TRANS/WP.29/658
16 February 1999

Working Party on the Construction of Vehicles

DRAFT 04 SERIES OF AMENDMENTS TO REGULATION No. 83
(Emissions of M1 and N1 categories of vehicles)

"Figure 1

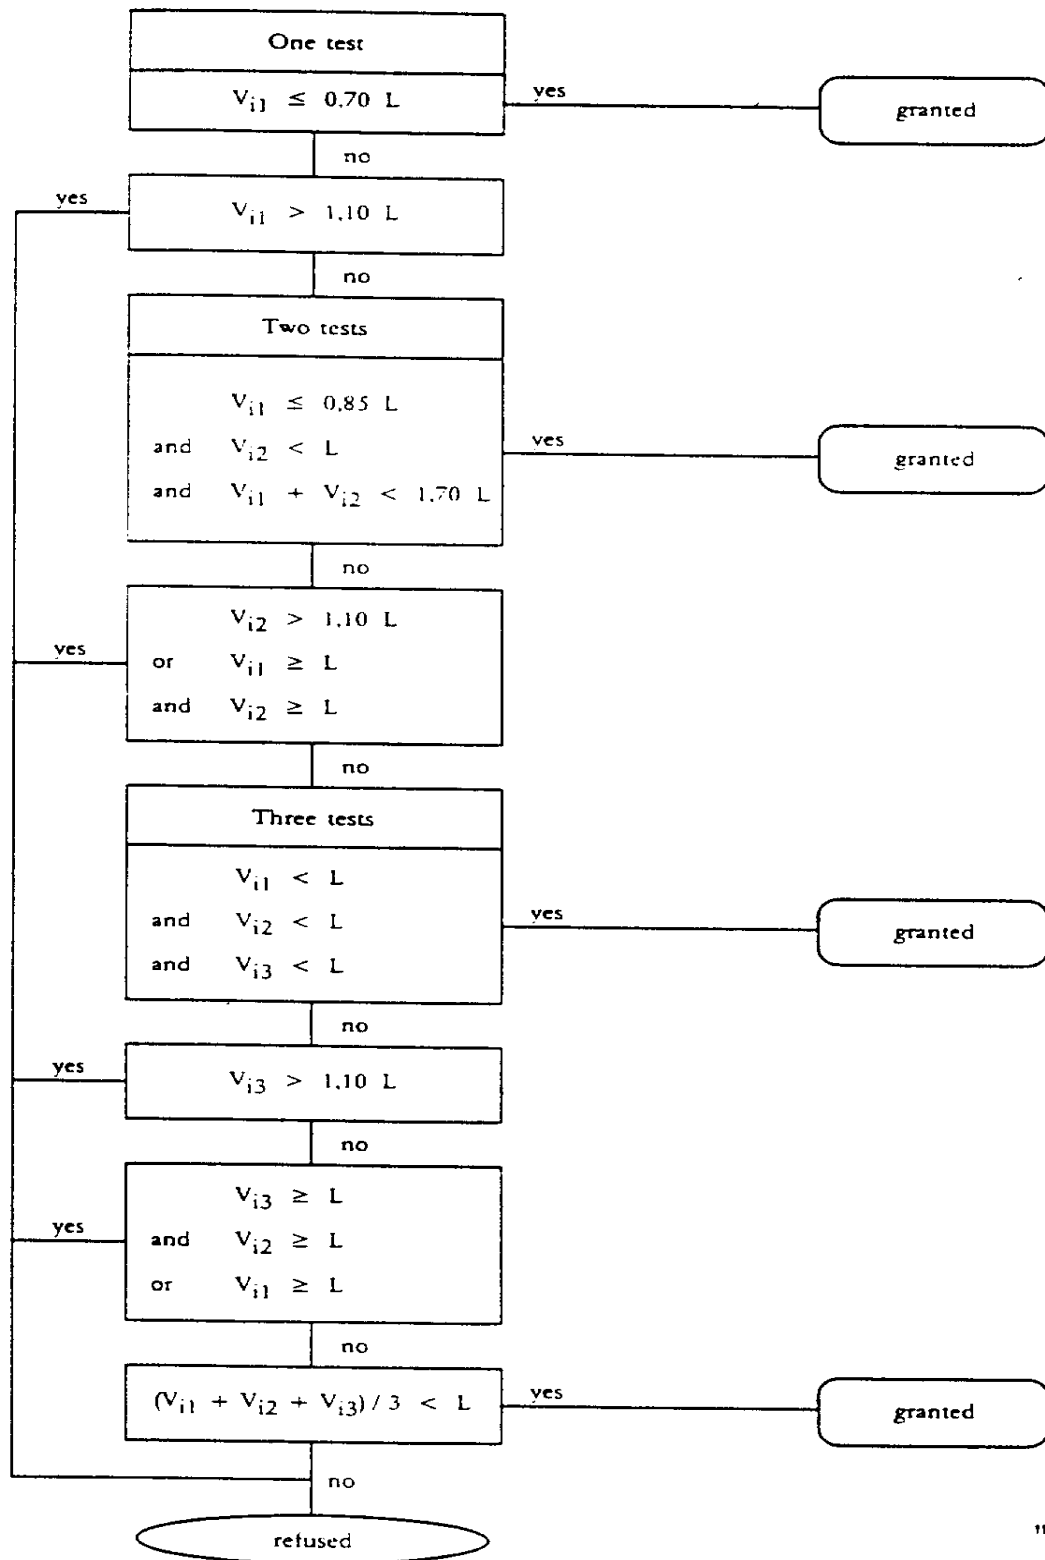
Figure 1, amend as follows:

Flow chart for the approval system type I tests

(see paragraph 5.3.1)

"Figure 2/1

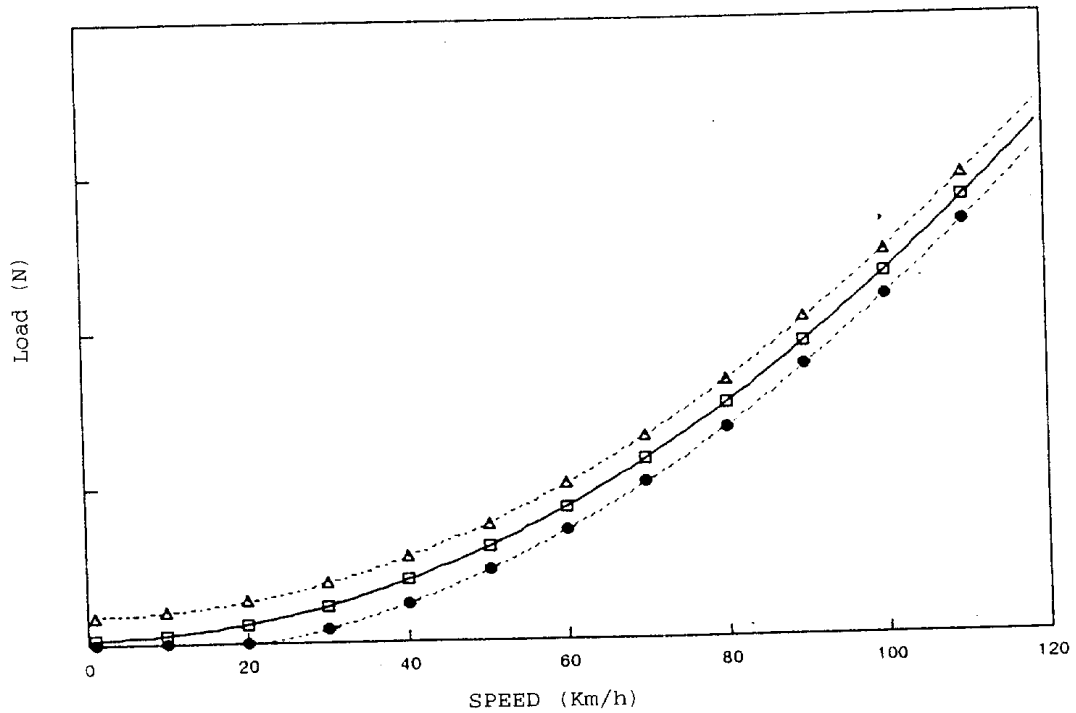
Figure 2/1, replace by the following figure:

Diagram illustrating the load of the chassis dynamometer

Figure 2/2

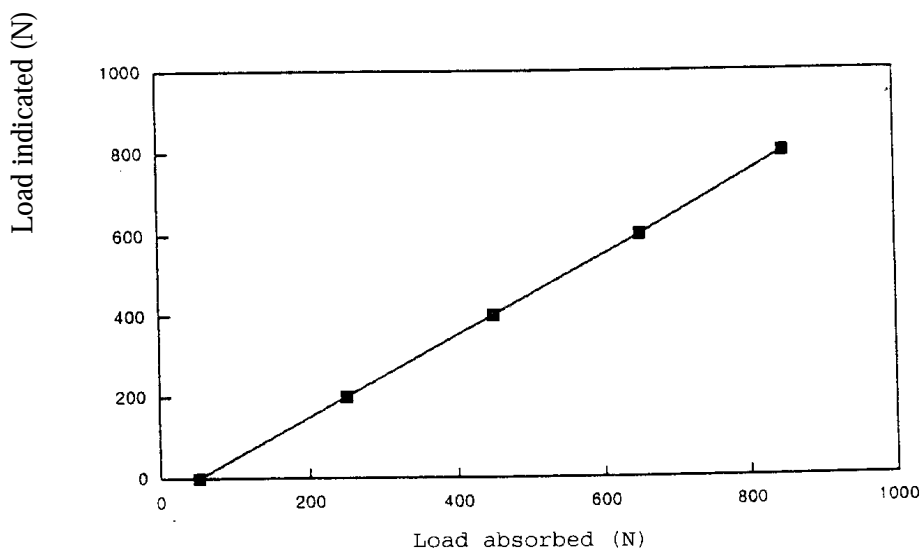
Figure 2.2, replace by the following figure:

Load indicated at 80 km/h in terms of the load absorbed at 80 km/h
